CITY OF PORTLAND BUILDING PERMIT

PERMIT ID: 2012-50421

has permission to **Installing stairs**

Robert Wiener - Re: New Park St images

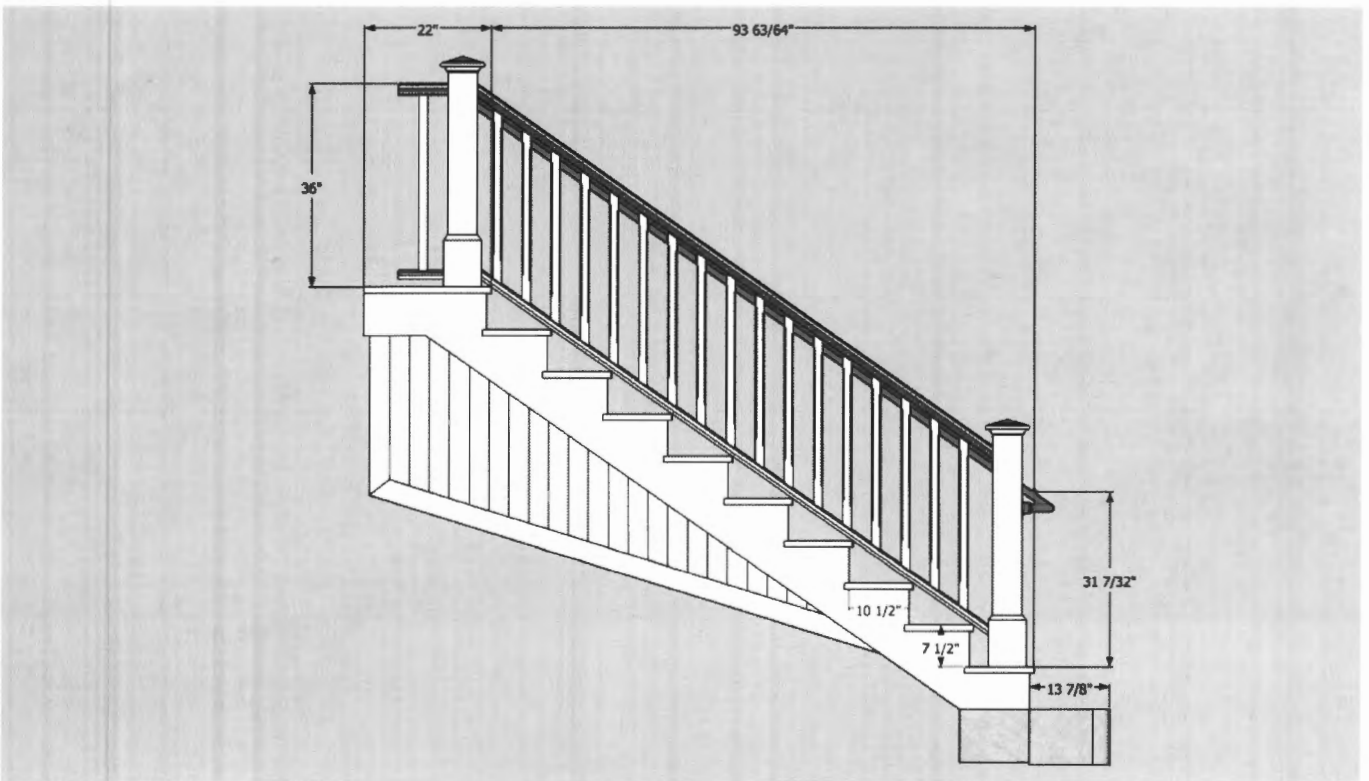
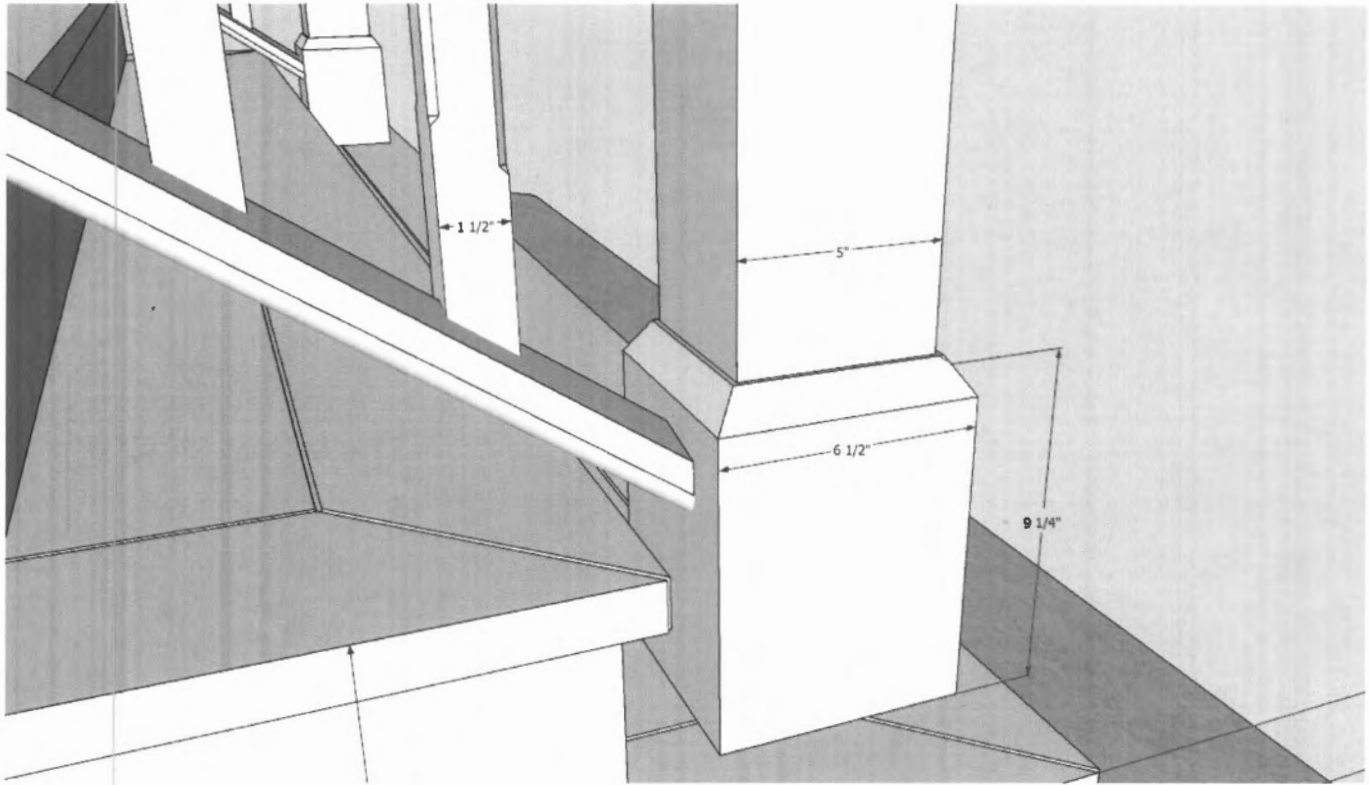
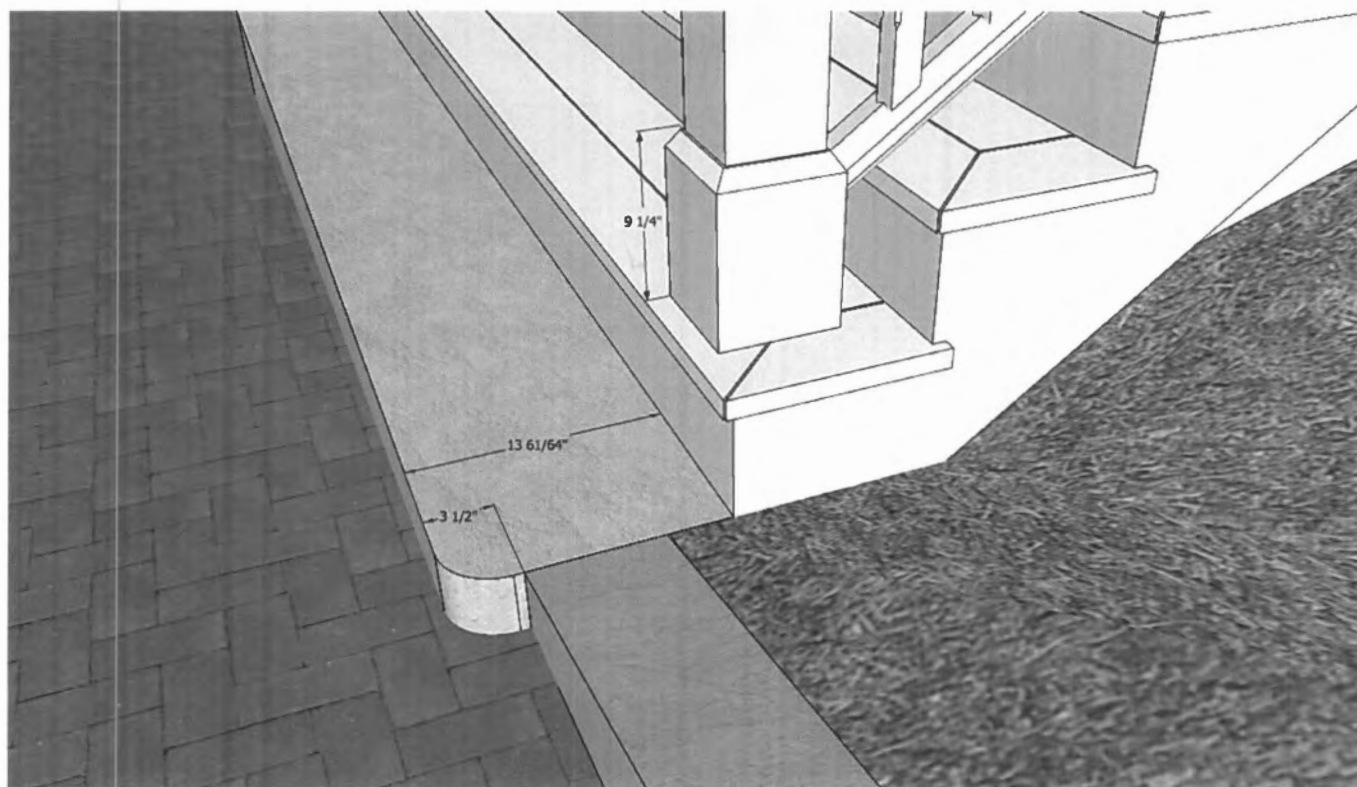
Looking good! We're getting close. A few suggestions:

- where curb to the right of the steps slopes down to match the end of the first granite step, can you make the transition a straight slope, and a little longer, more gradual?
- hoping the mason can round the corners of the first step, where it sticks out (we talked about this, I'm guessing it's not worth trying to draw it.)
- show the post bases with a minimum height of 7.25" (1x8)
- We want to make sure we have an image with dimensions, showing component sizes, heights, the amount of that 3.5" projection, etc.

Attached are the new images for the Park St project with the requested changes made. The bottom granite step on the front stairs projects 3.5" past the curbing into the sidewalk and is 3.5" on the low side and 9.5" on the high side. If you would like some different angles here, or some dimensions, let me know.

I think you are good to go. The city engineer has given the go-ahead for the bottom step - see below. I think we're happy with everything else, except we'd like to see the iron handrail return into the side of the newel, instead of wrapping around the front. I think it's almost as easy to grab there, as it would be from the front, and it would be good not to have it on the front of the post. And at the top it appears that the short level rail hits the pilaster just below the panel molding - that looks good.

Public Services has reviewed this request and we have no issues with the bottom granite step being installed as proposed.

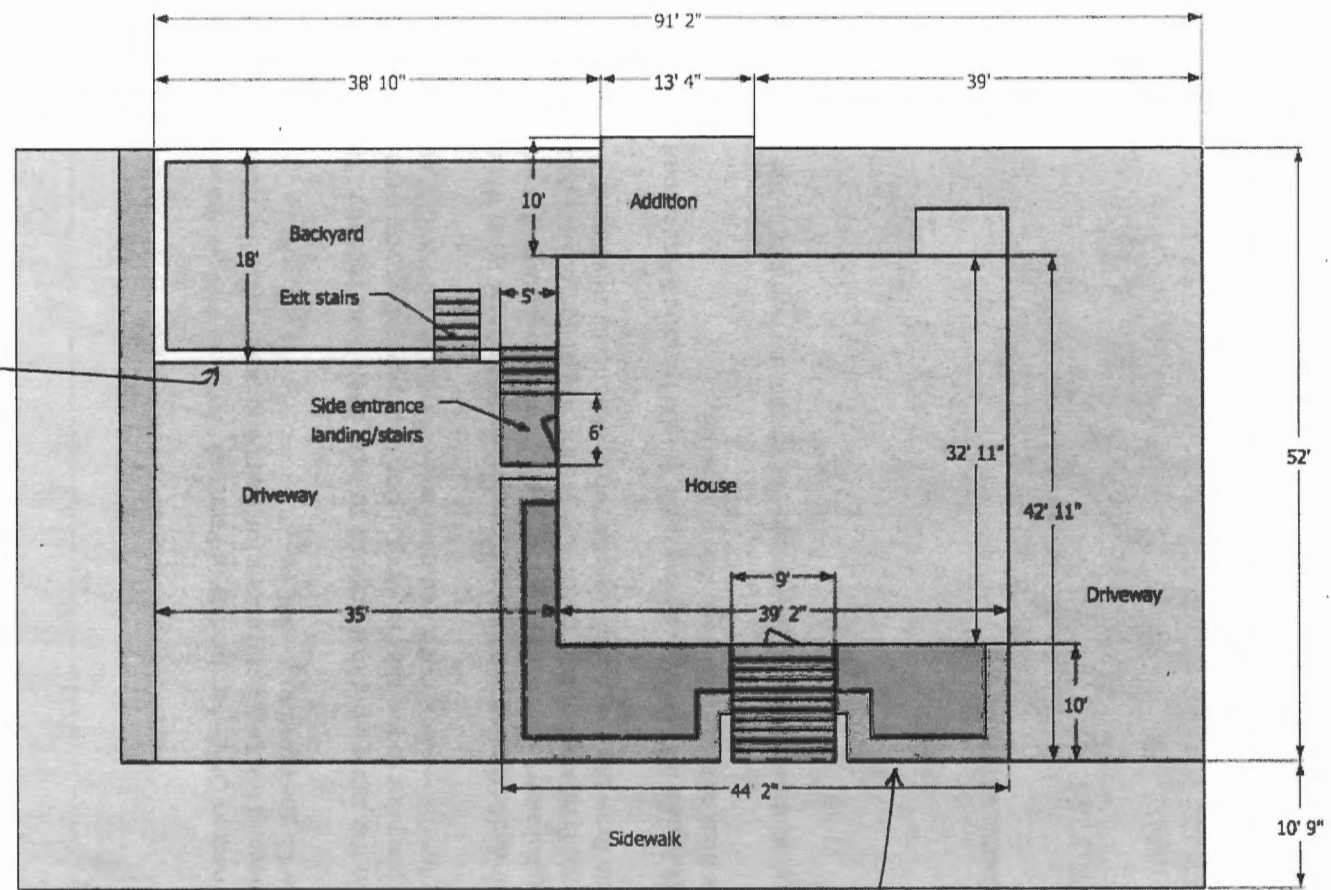
Thanks for speaking with me this morning, and for your help with this matter. I'm attaching some of Andrew Mayer's sketches and the tax photo. It appears that the bottom of the stairs may have projected beyond the curbing at the front of the yard.

ORIGINAL PROPOSAL-

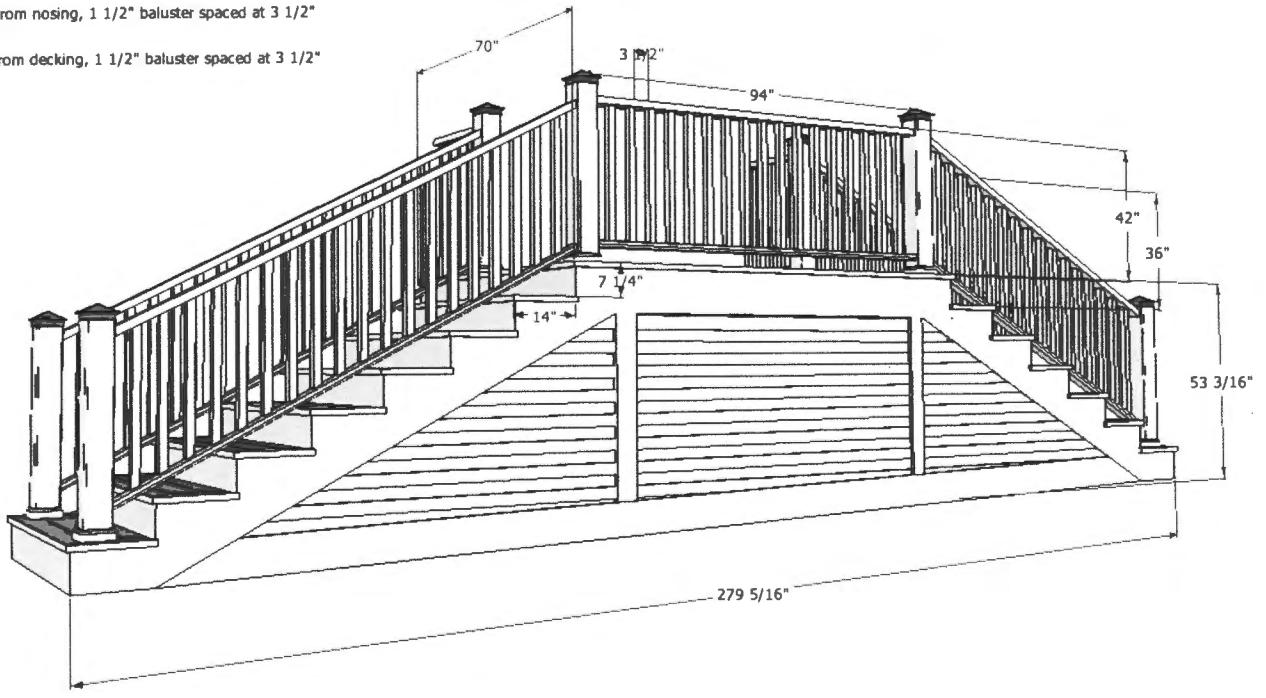
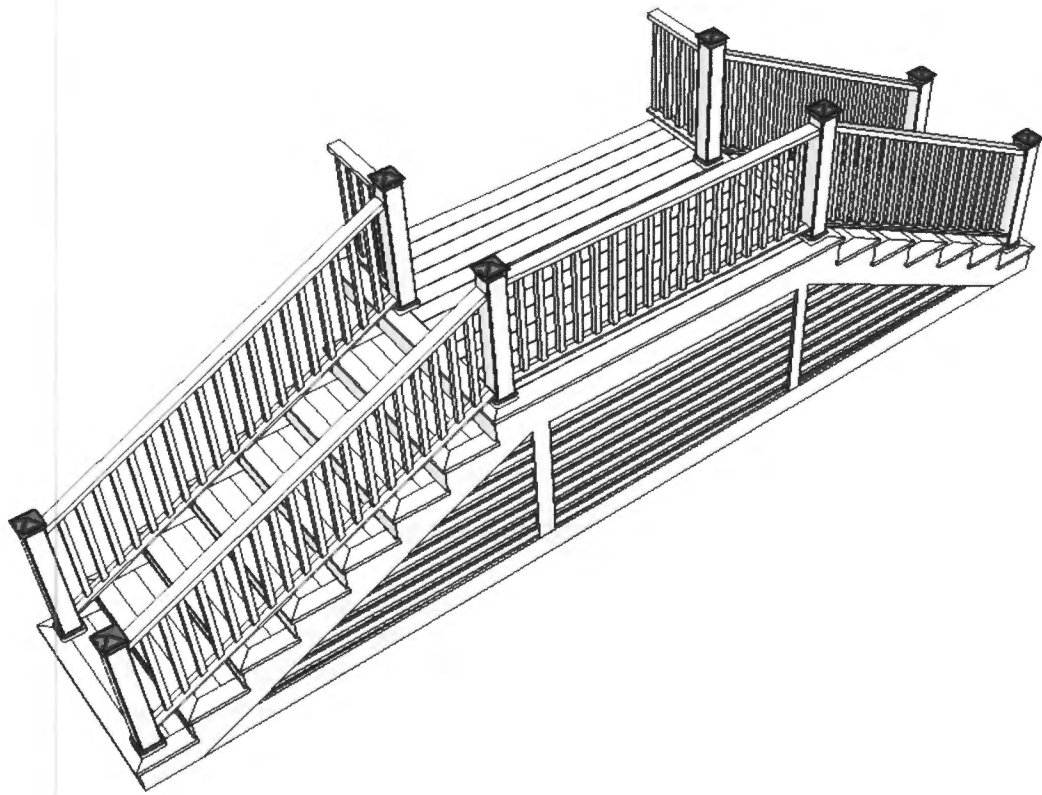
NOT APPROVED BY HP

ORIGINAL
PROPOSAL
PRESENTED
ON 1/16
